STERLING RECYCLING FACILITY

STREET IMPROVEMENT PLAN

STERLING RECYCLING FACILITY
COVER SHEET
SHEET 1 OF 10
JOB NO. 25188.14

STERLING RECYCLING FACILITY
HORIZONTAL CONTROL PLAN

**TEMP CUL-DE-SAC PROFILE
STA 1+00.00 TO 5+30.87**

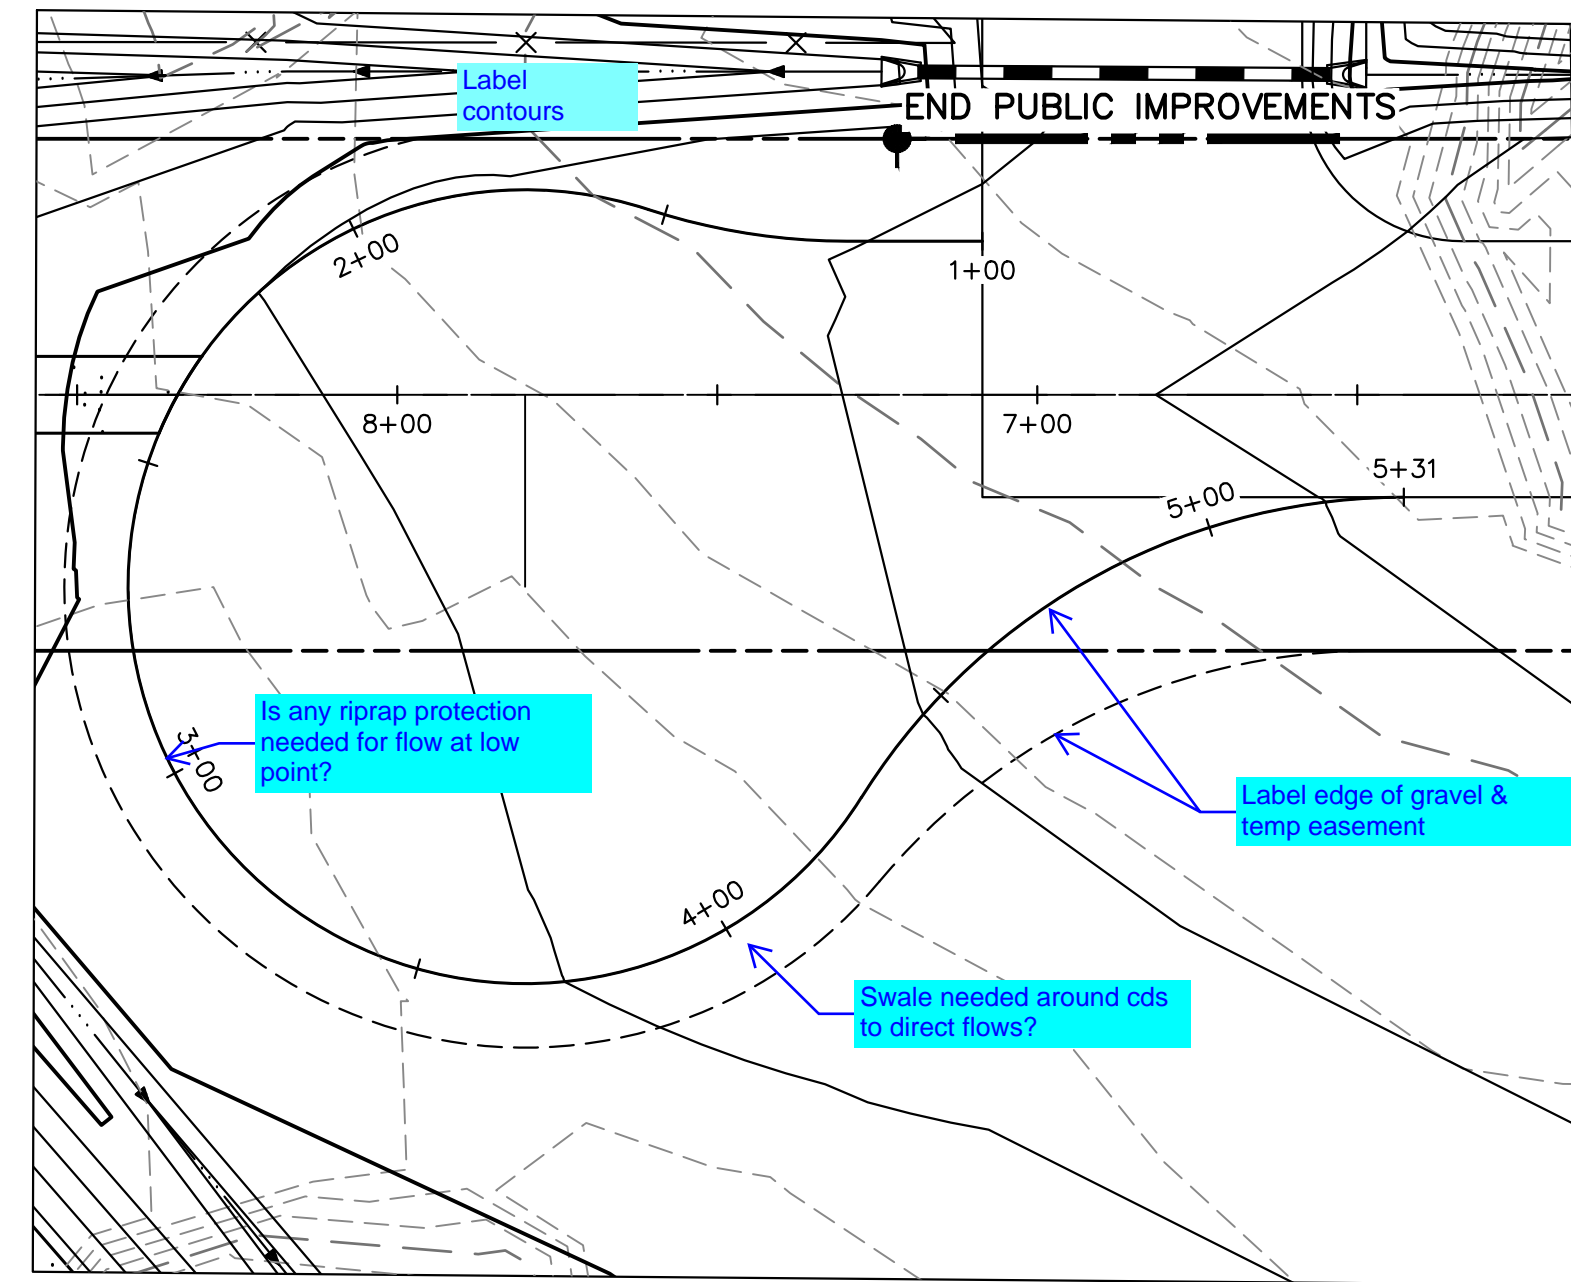
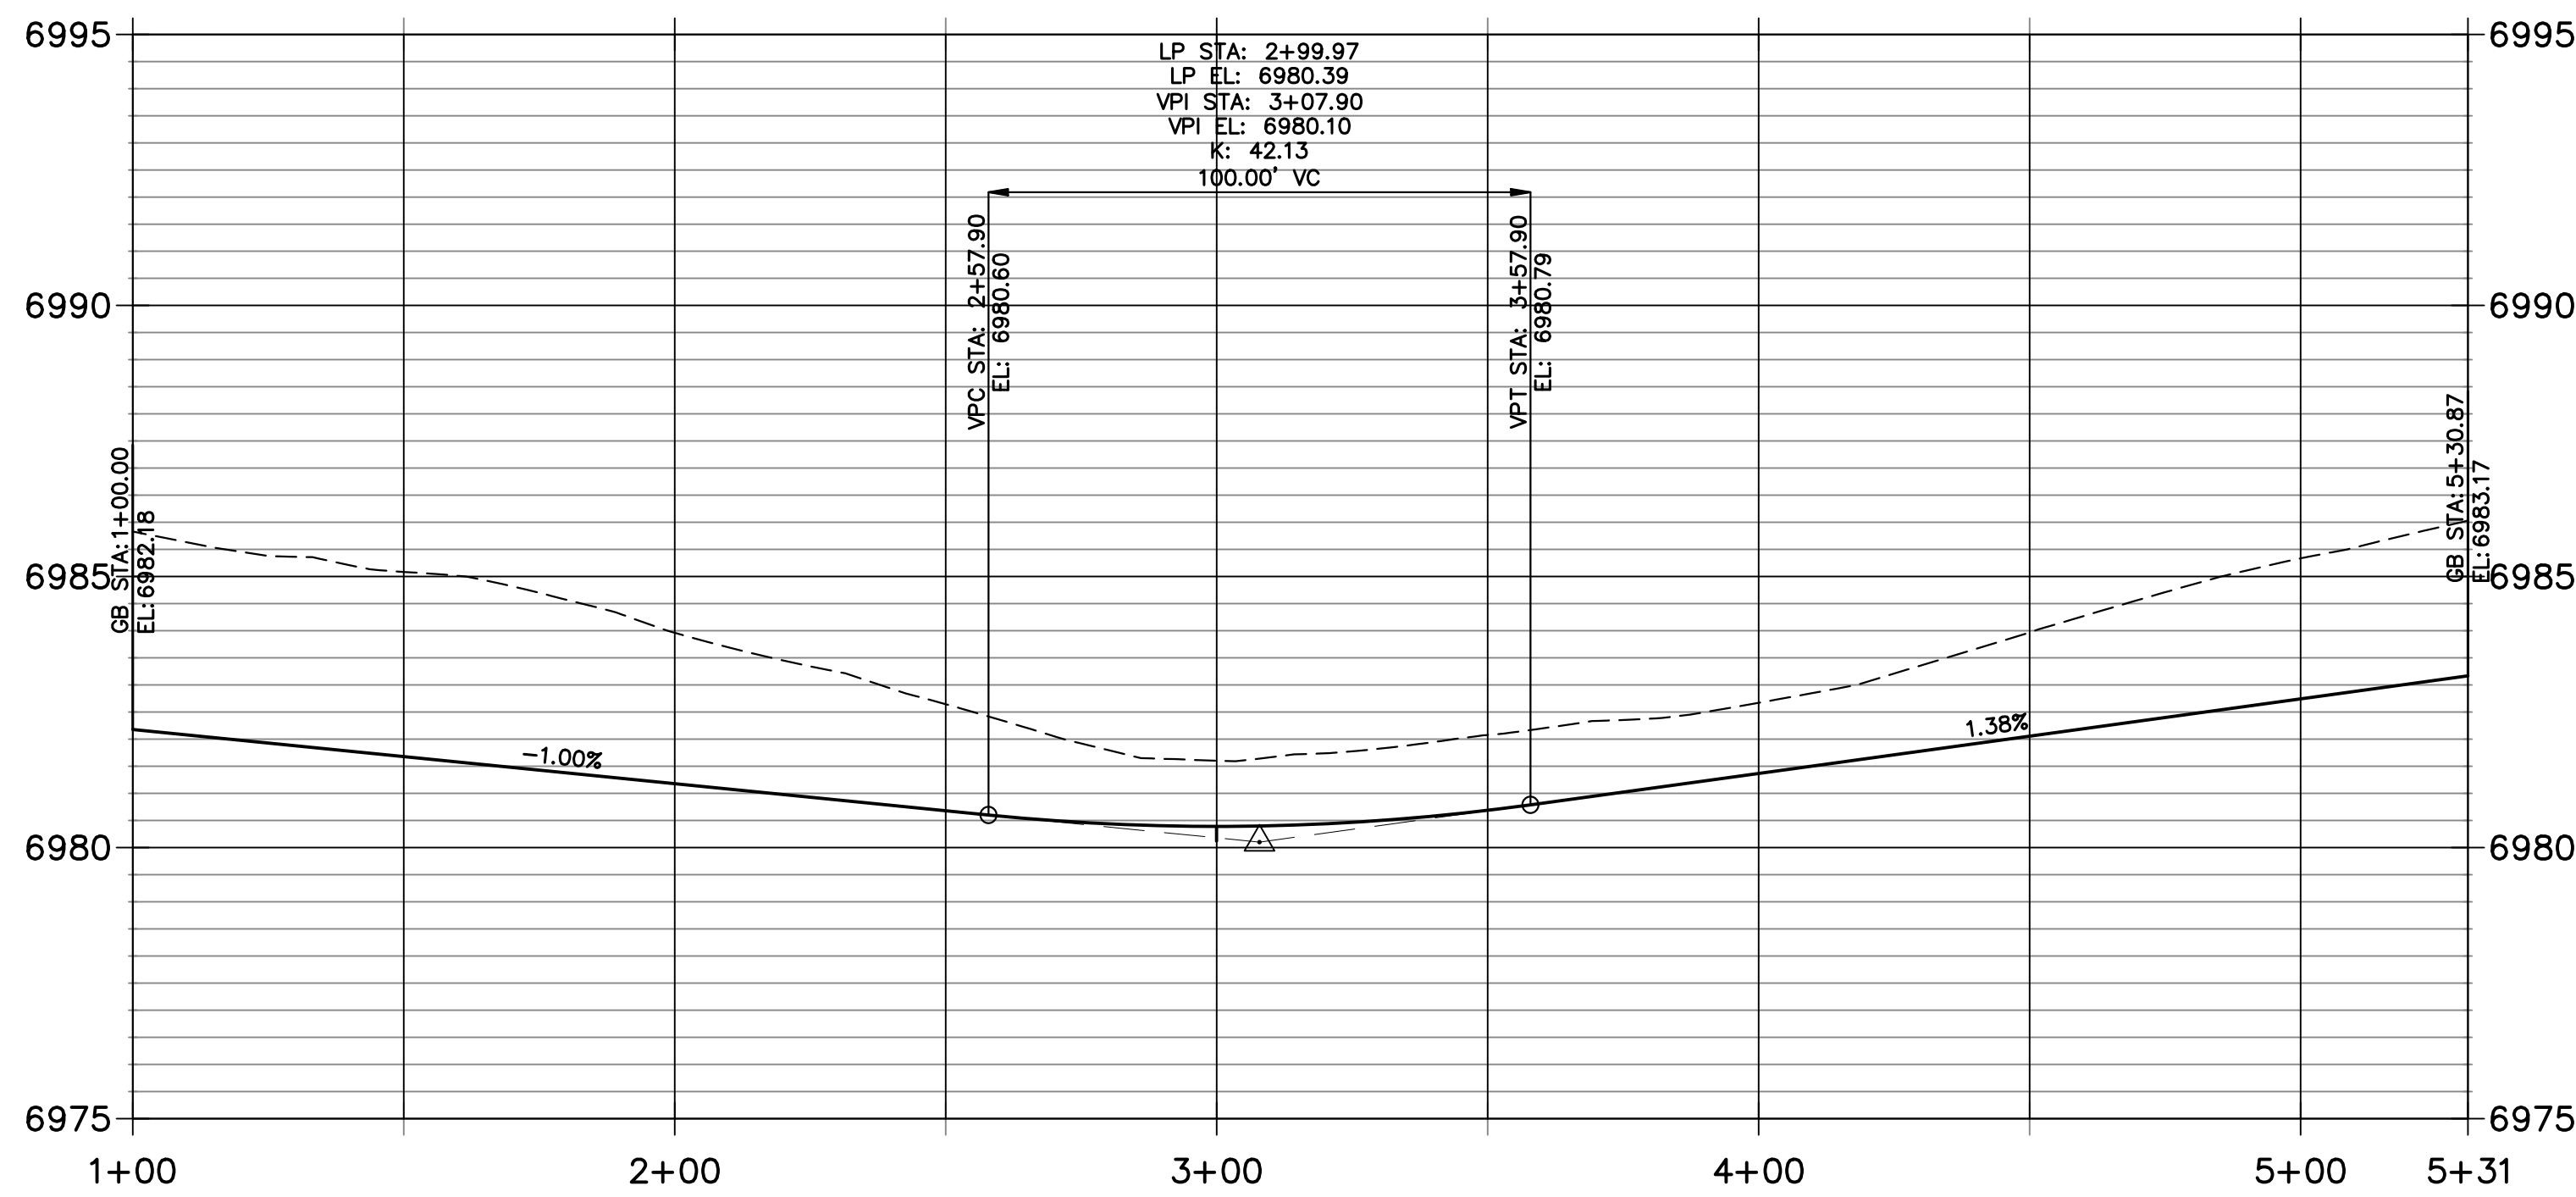
If SRR is not proposing any c&g during interim condition, include some protection at end of curb return (c&g) to disperse flow.
